RECEIPT DATE: 3/15/19 **ONSITE SEWAGE DISPOSAL SYSTEM**

RE: OSDS Plan
12344 Howard Lodge Drive
Sykesville, MD

The OSDS Plan for has been reviewed with the following comments:

SEPTIC SYSTEM
INSTALLATION PLAN
CLOPEIN PROPERTY
LOT 7-C

SEPTIC PROFILE
SCALE: 1" = 30'

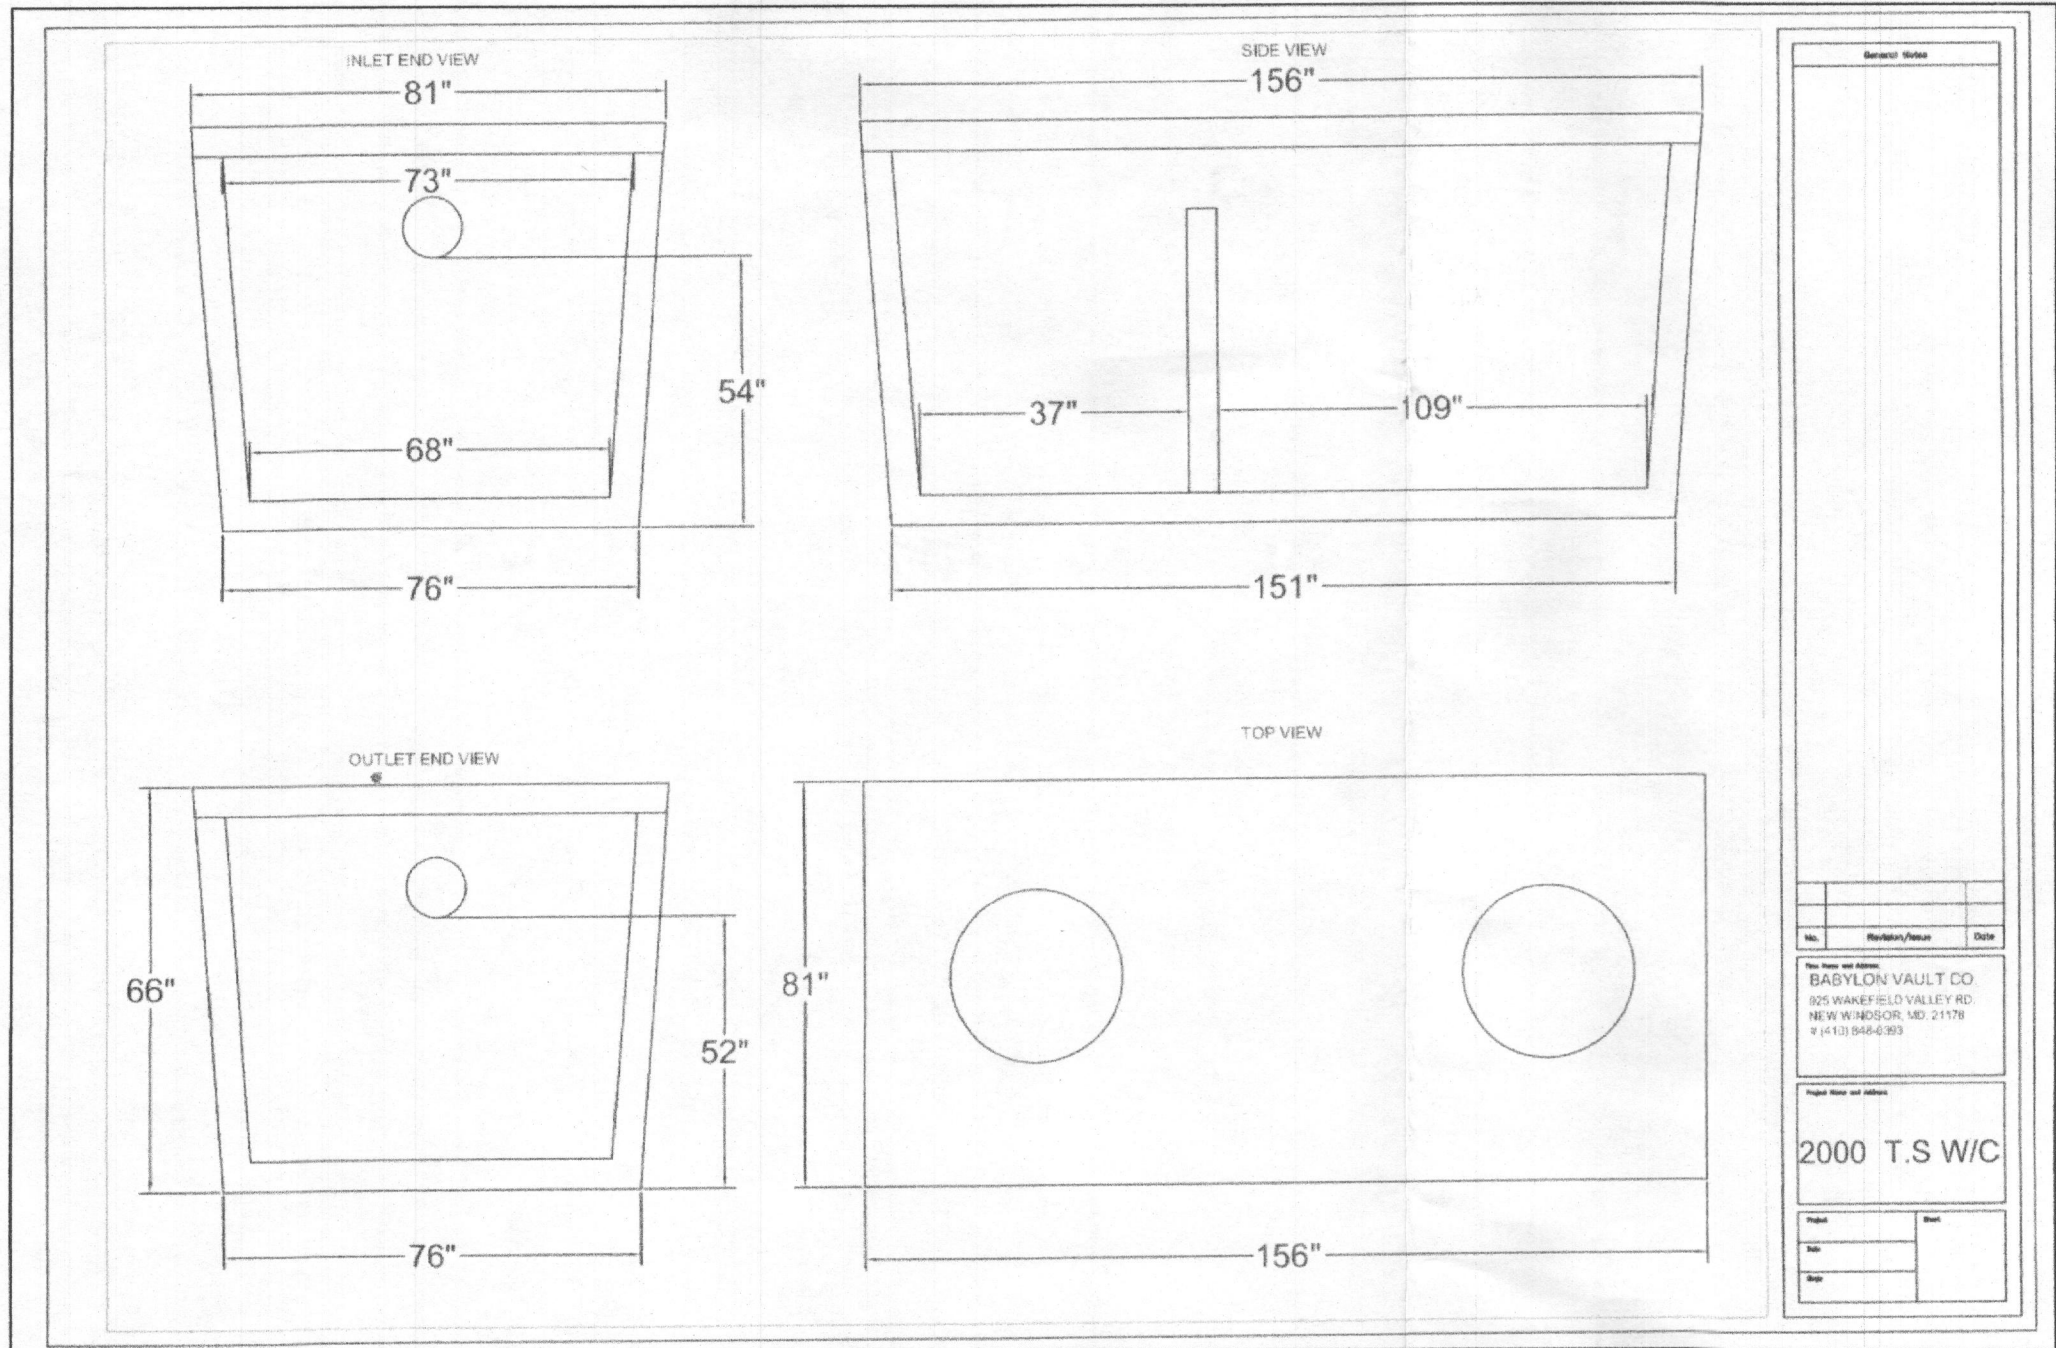
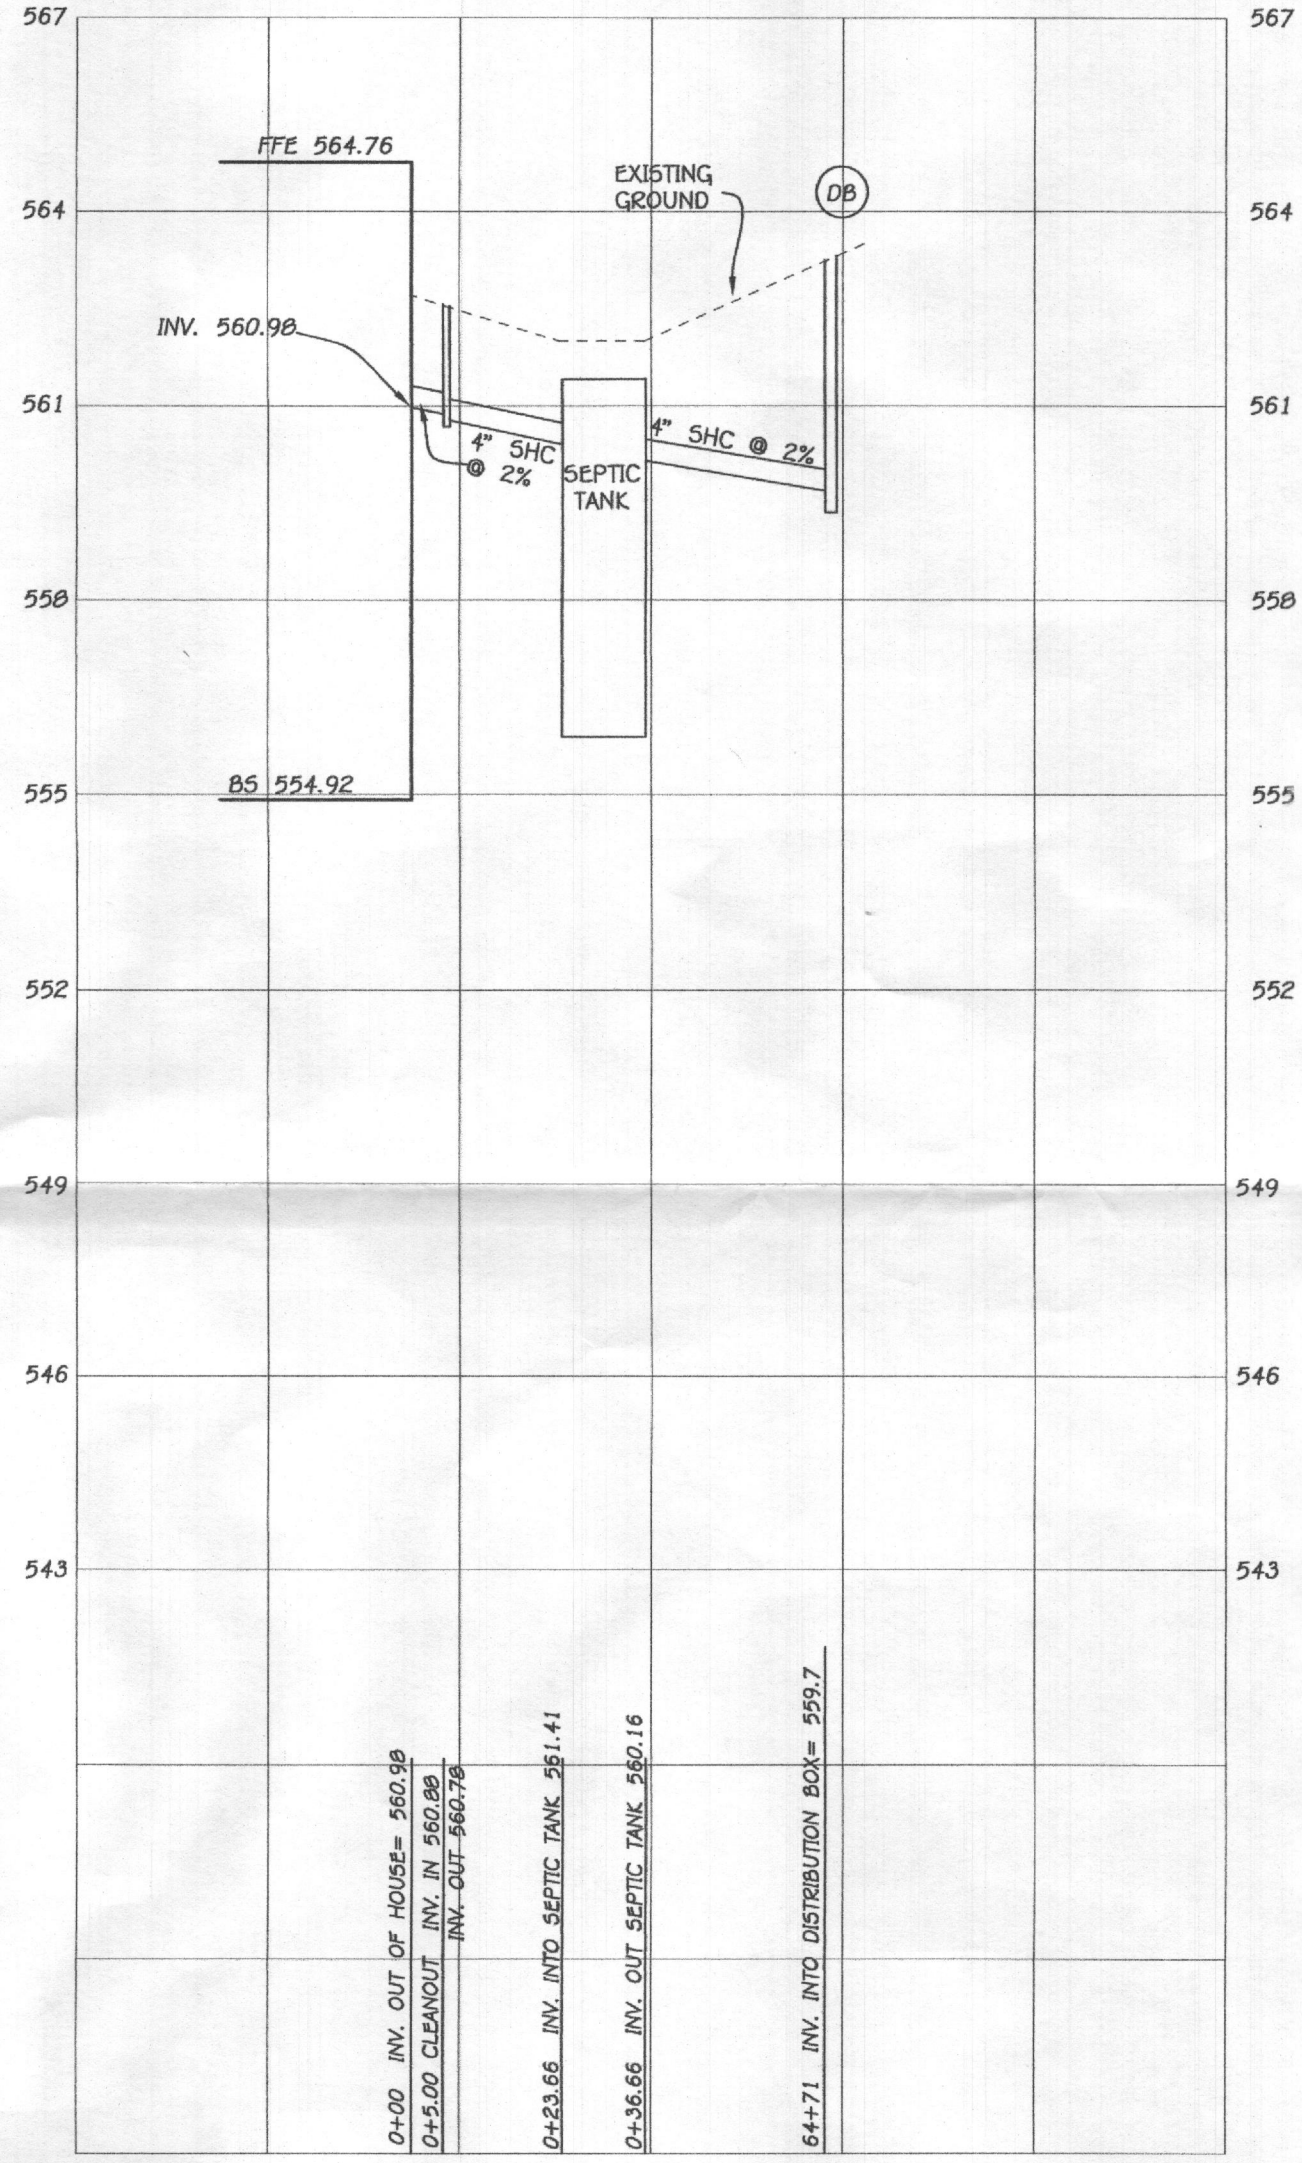
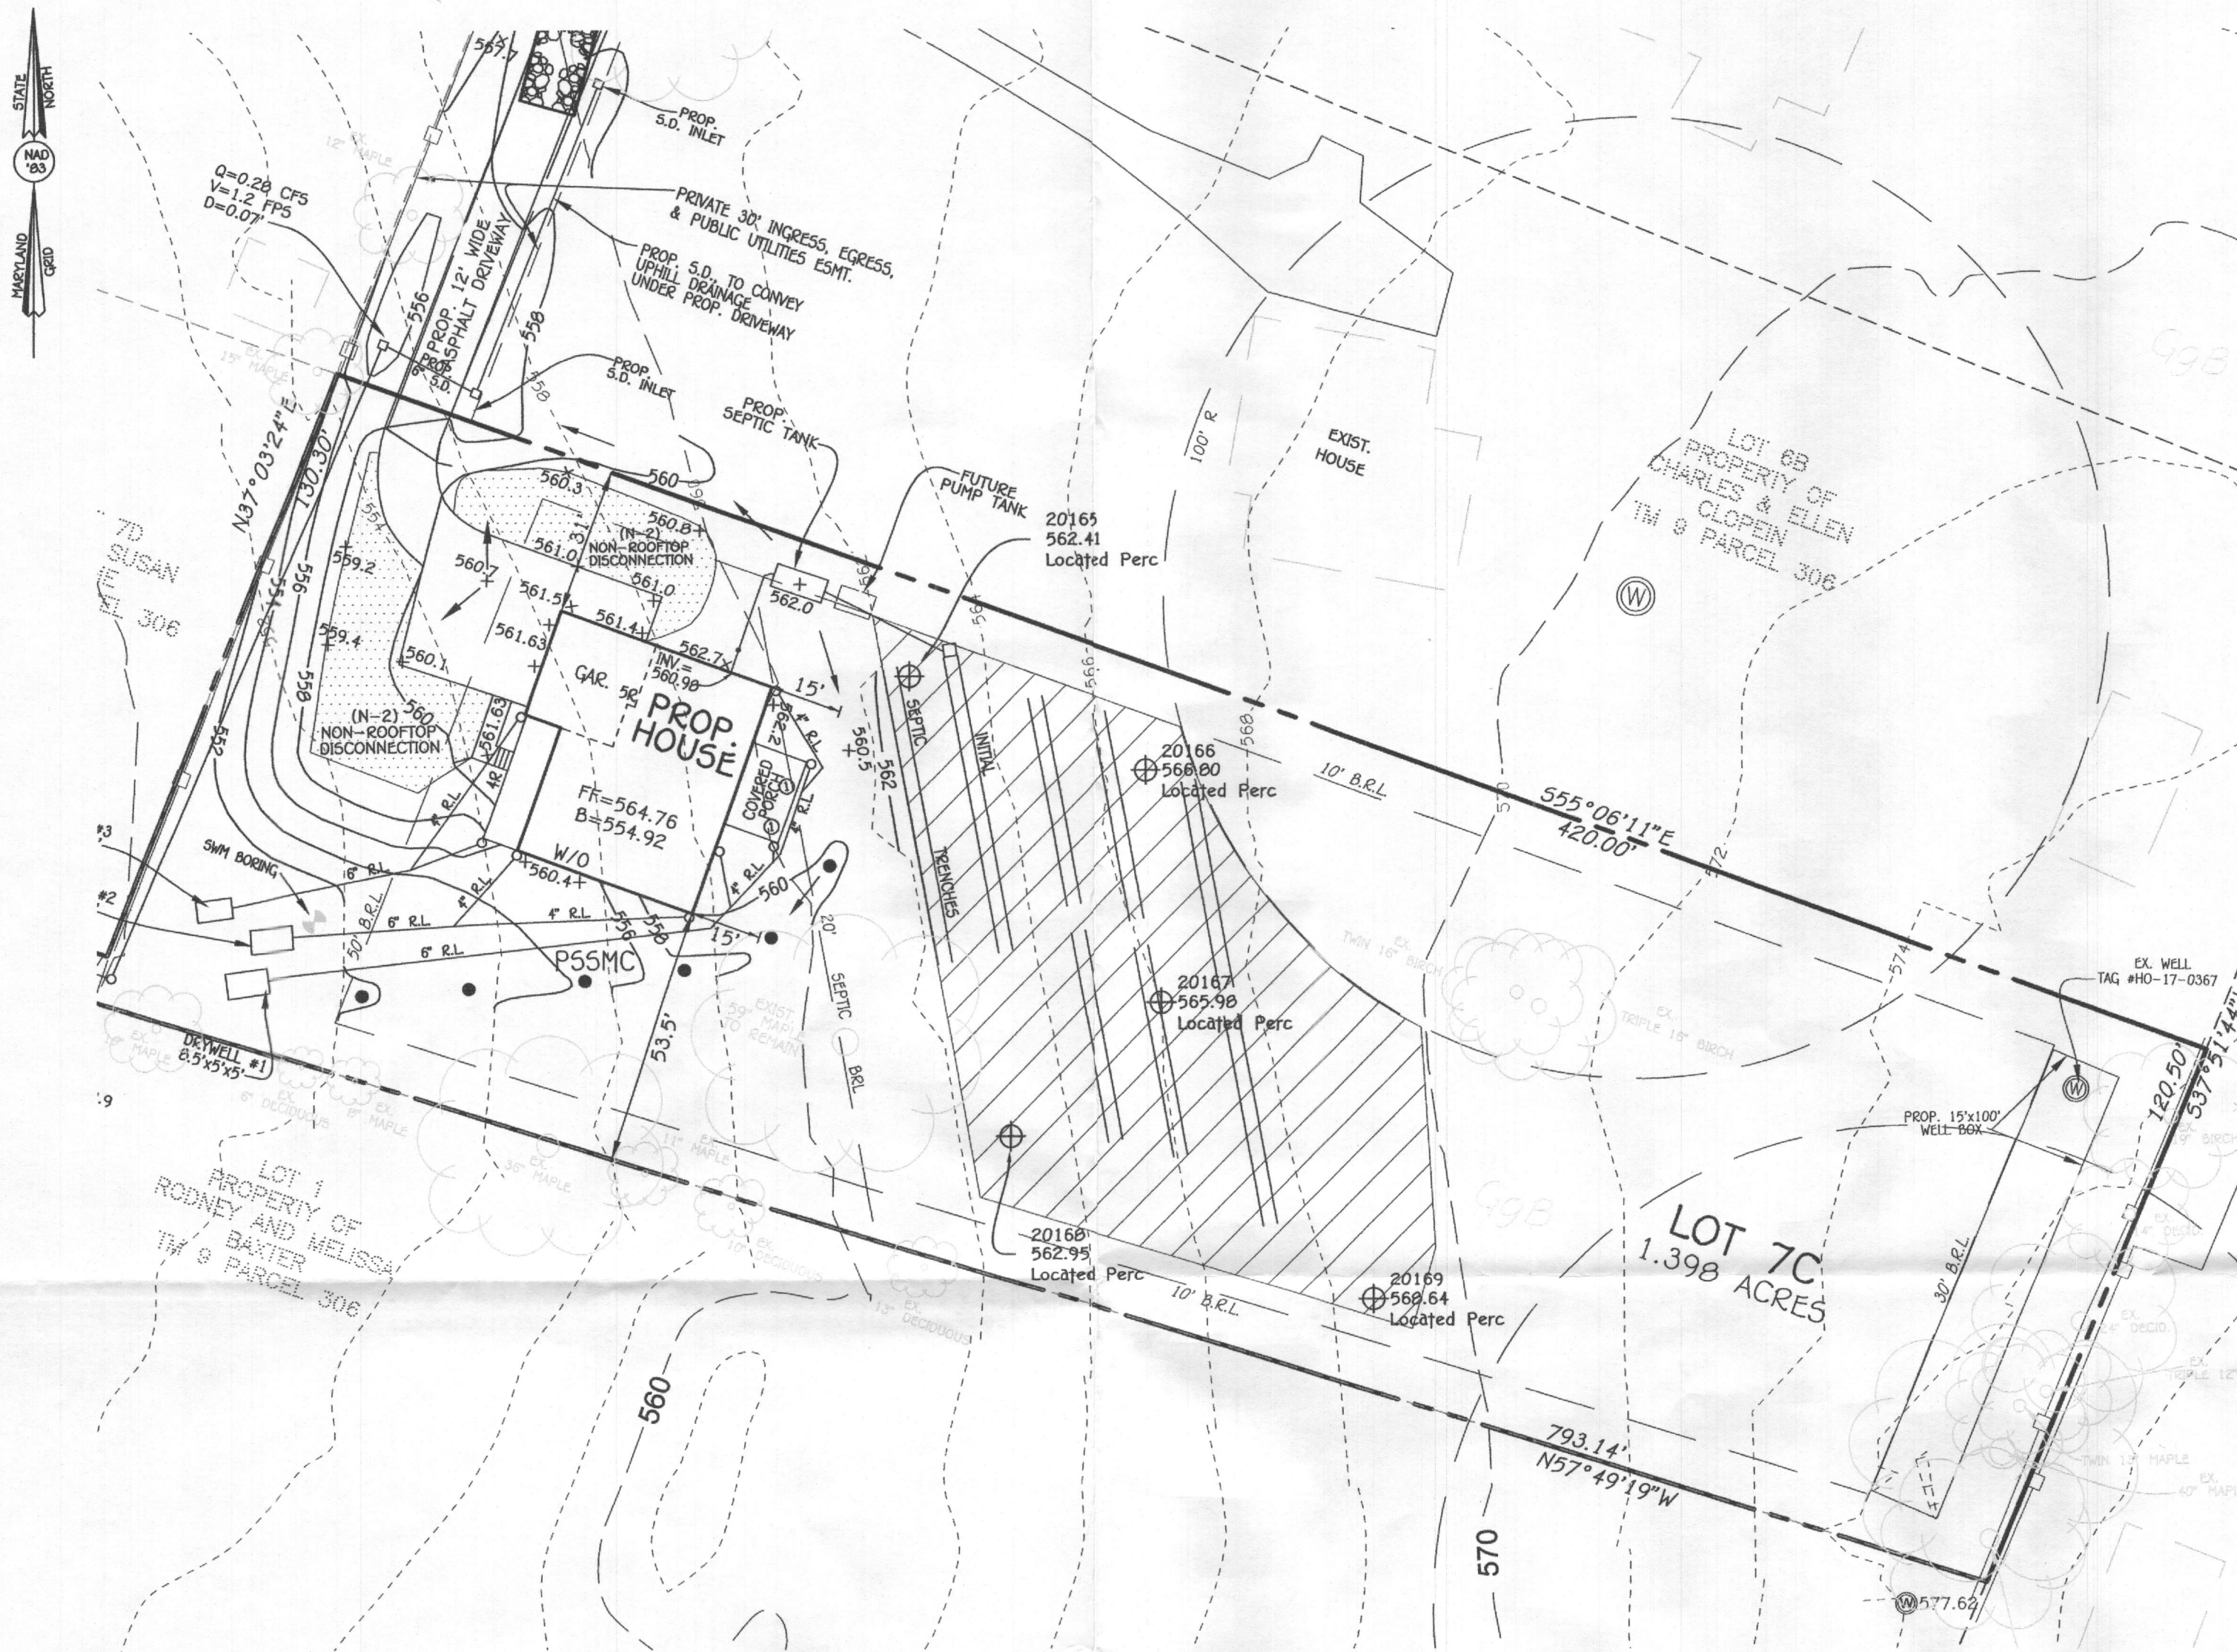
- 1.) The ground elevation of 562.7 shown above the invert out of the house does not to match up with the given elevations on the plan. In addition, the ground elevation of 562.1 above the septic tank also does not align unless there is grading not being shown on the plan.
- 2.) If you are splitting trenches, then the d-box must be positioned in the middle of the trenches. If this cannot be accommodated, then run 2 – 62.5 ft. trenches and use the rest of the area beyond the ends of these trenches for the 1st replacement system.
- 3.) Add comment to plan to indicate if field conditions don't match the wall check or the septic design plan at time of installation, then a revised septic plan will be required which may include the use of a pump tank.
